TRAFFIC CIRCULATION LAYOUT APPROVED
Signed: [Signature] Date: 1/7/11

TACO BELL #3897 REMODEL
SAN MATEO / LOMAS
5215 LOMAS BLVD, NE
ALBUQUERQUE, NM

SHEET NAME
SITE PLAN
SHEET NUMBER
SD-1.1

1 SITE PLAN
Scale: 1" = 10'-0"

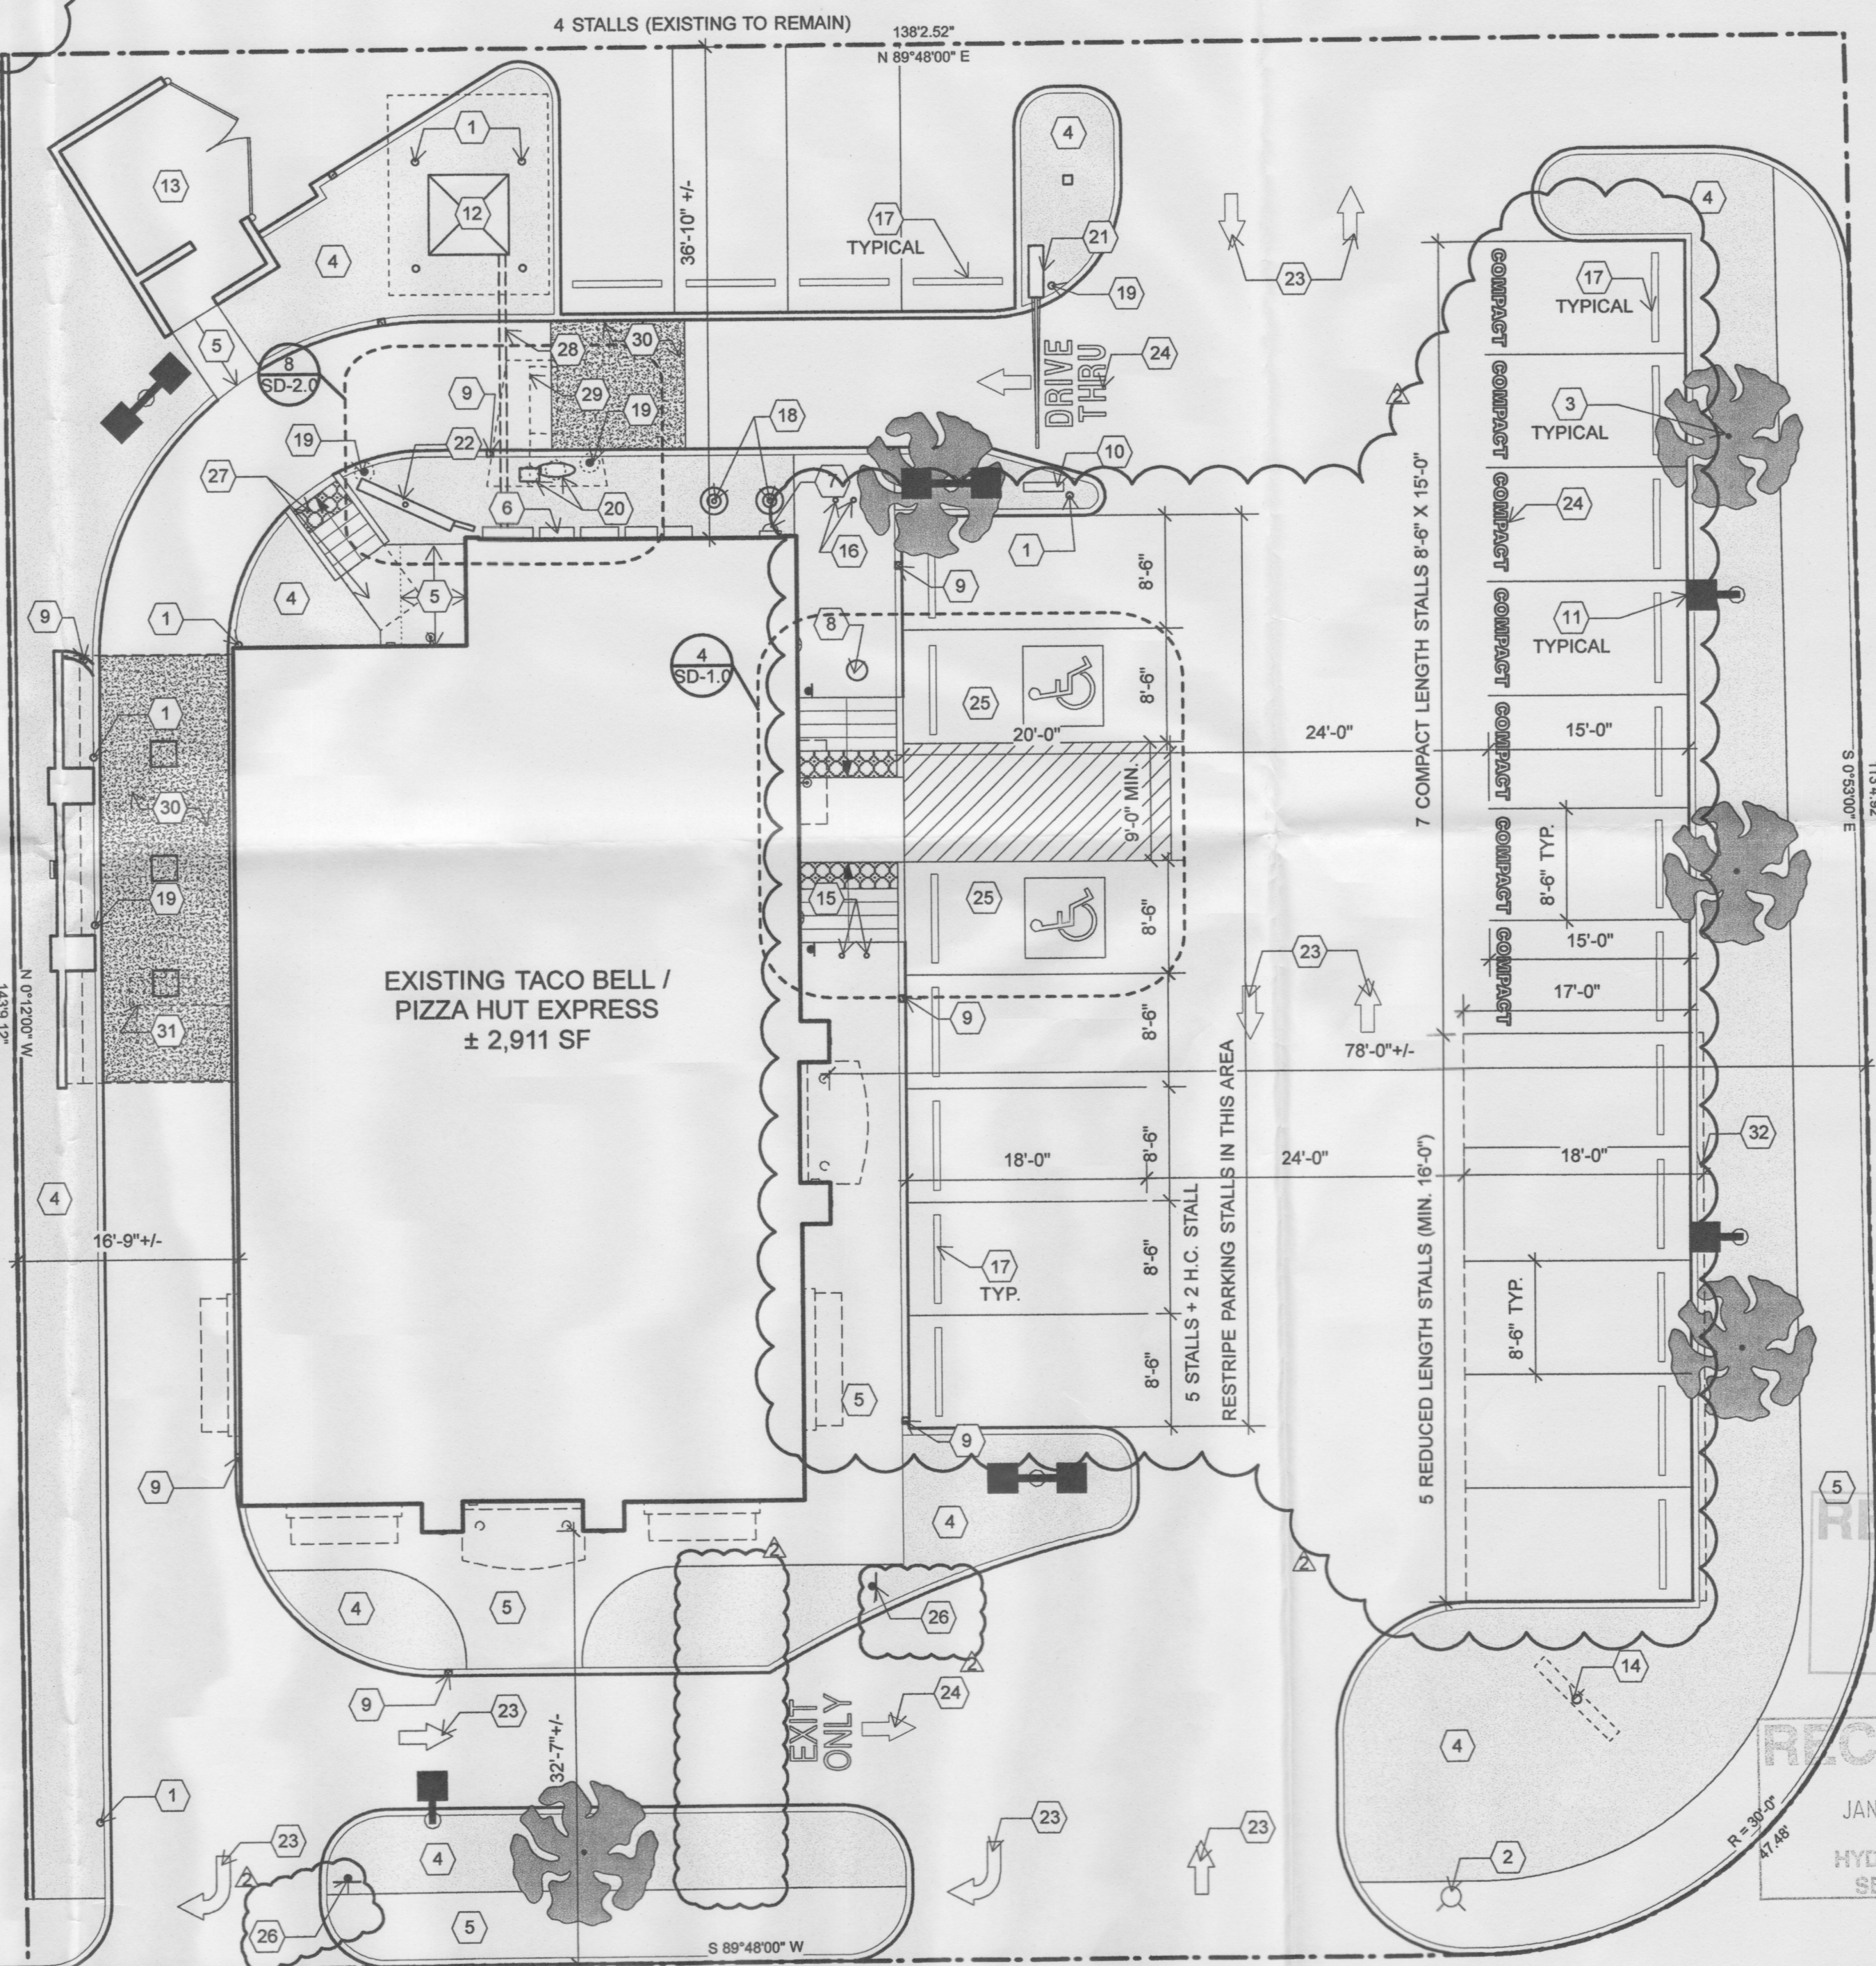
ZONING ENFORCEMENT
City of Albuquerque
Public Infrastructure shown on these plans for information only and not part of approval. Separate DRC/Permit approval and Work Order required.

1 SITE PLAN
Scale: 1" = 10'-0"

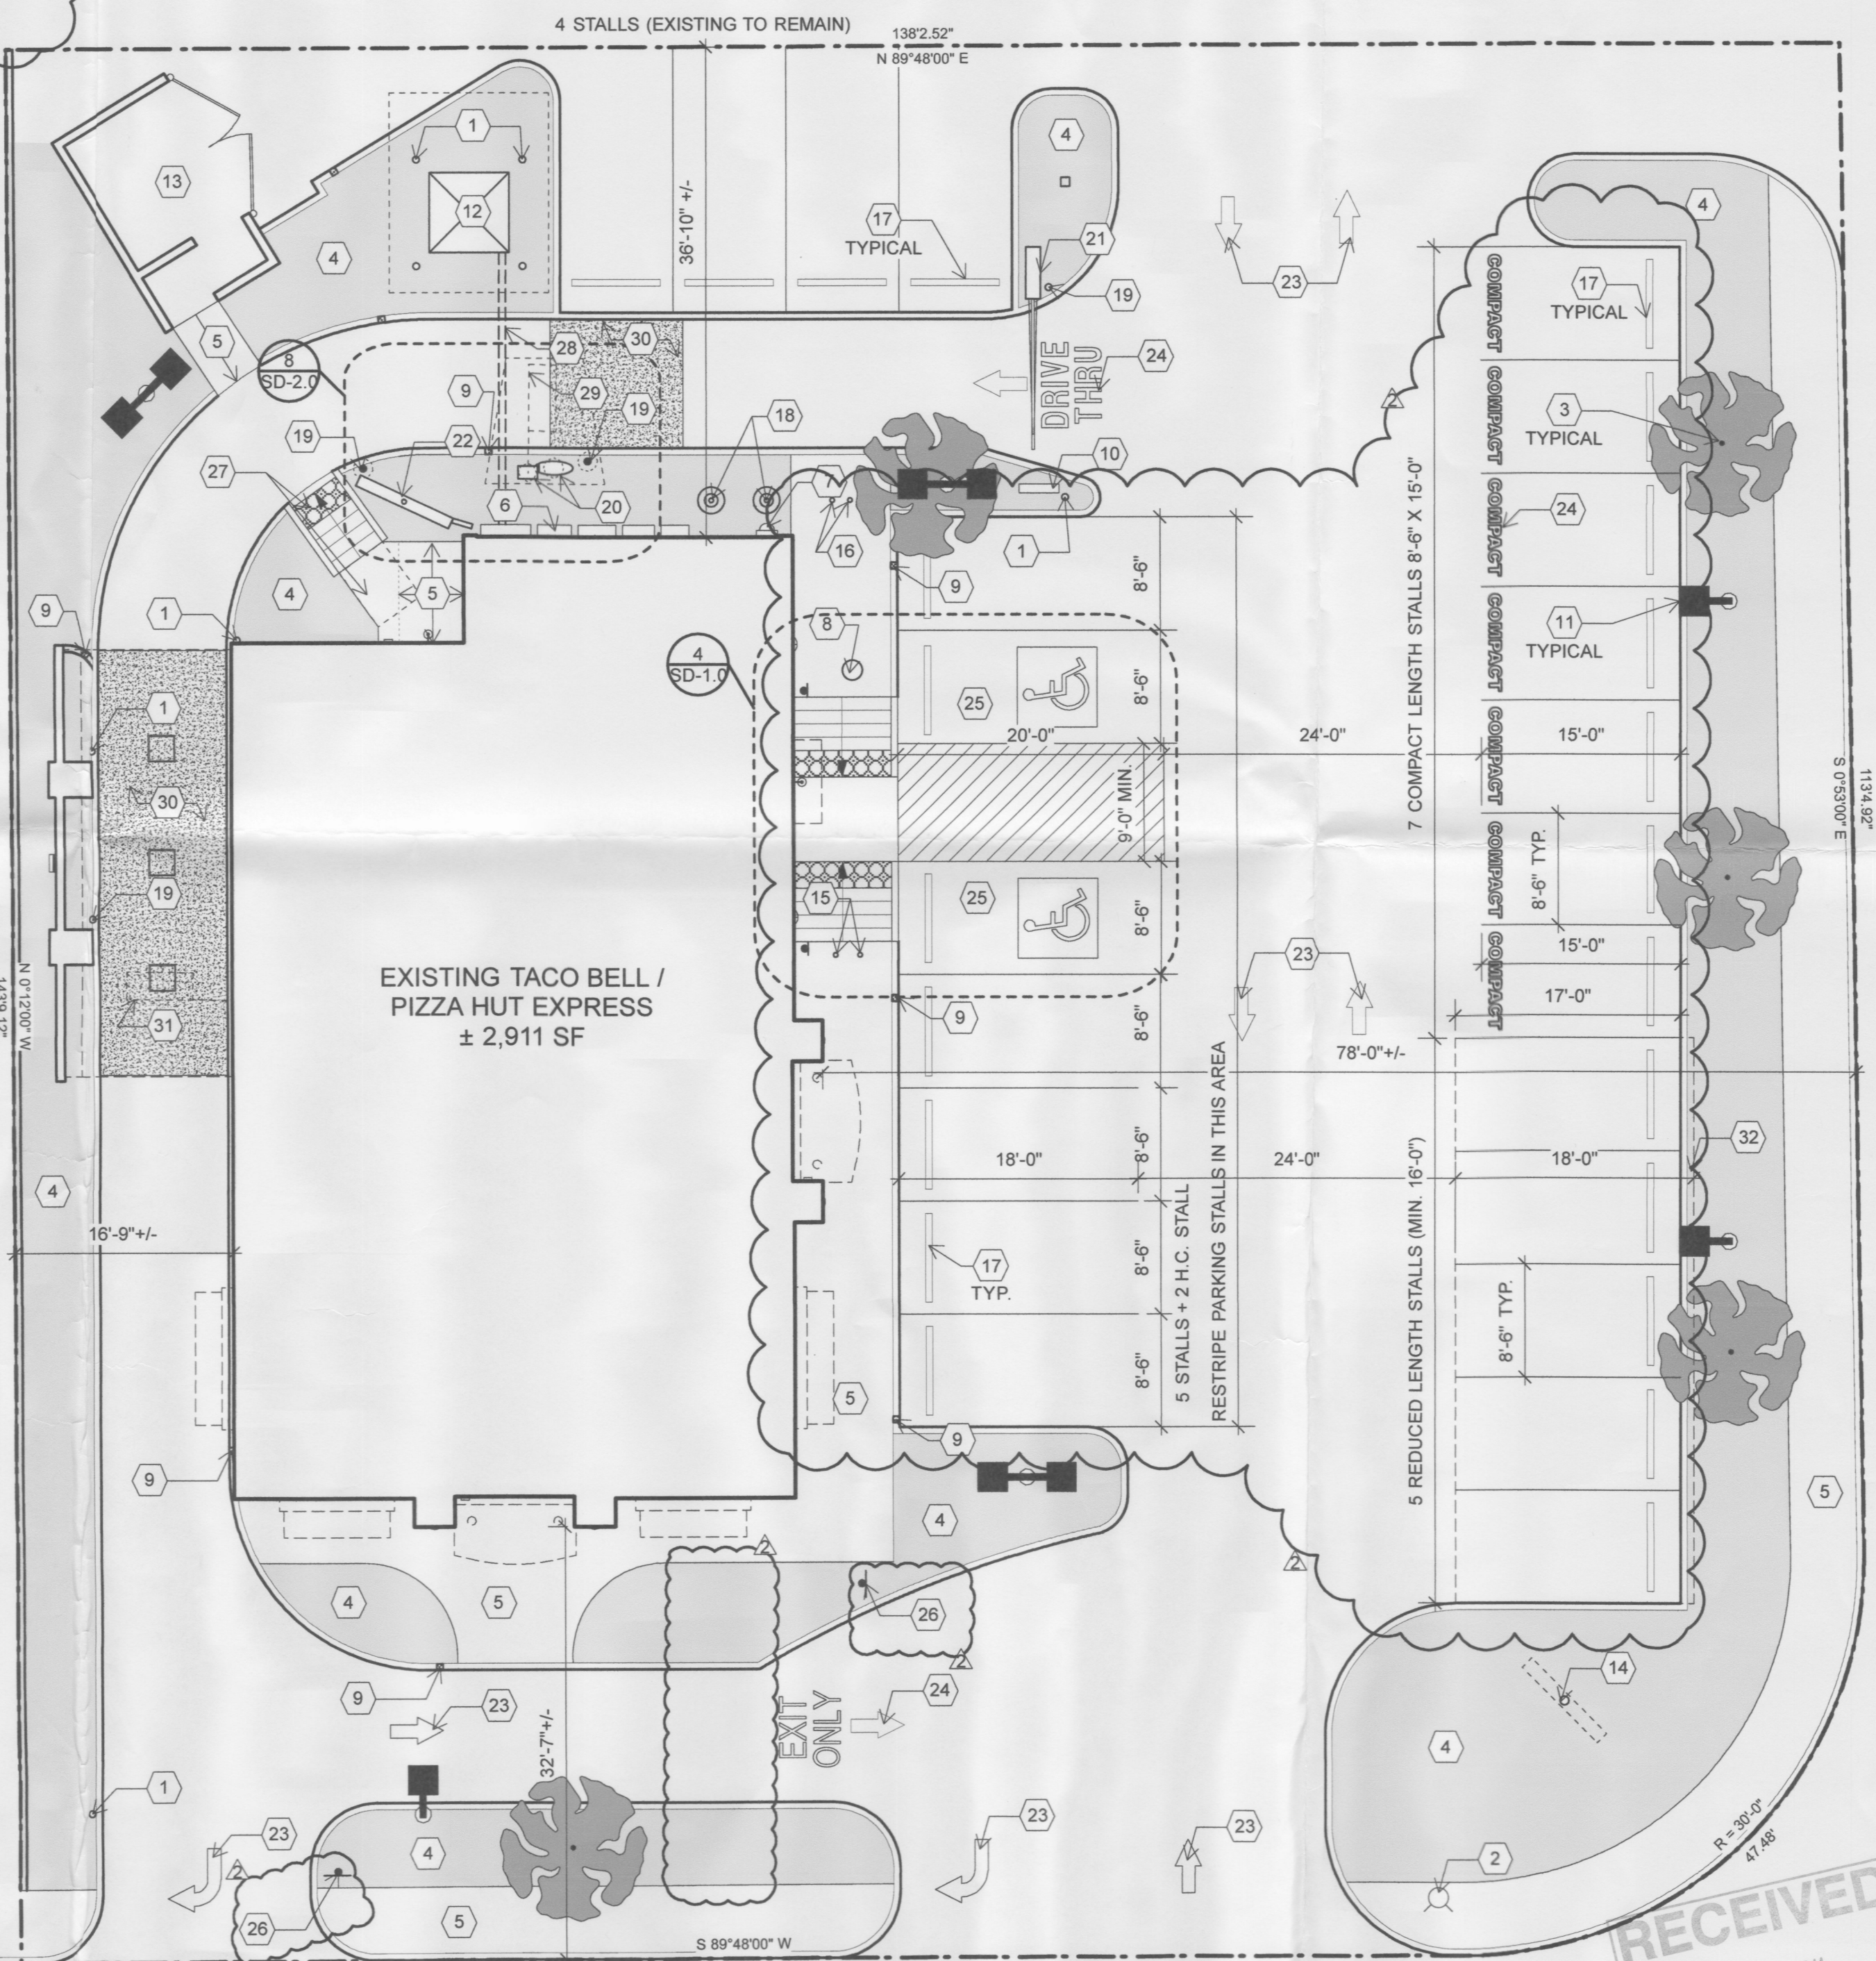
ALL WHEELCHAIR RAMPS LOCATED WITHIN THE PUBLIC RIGHT OF WAY MUST HAVE TRUNCATED DOMES.
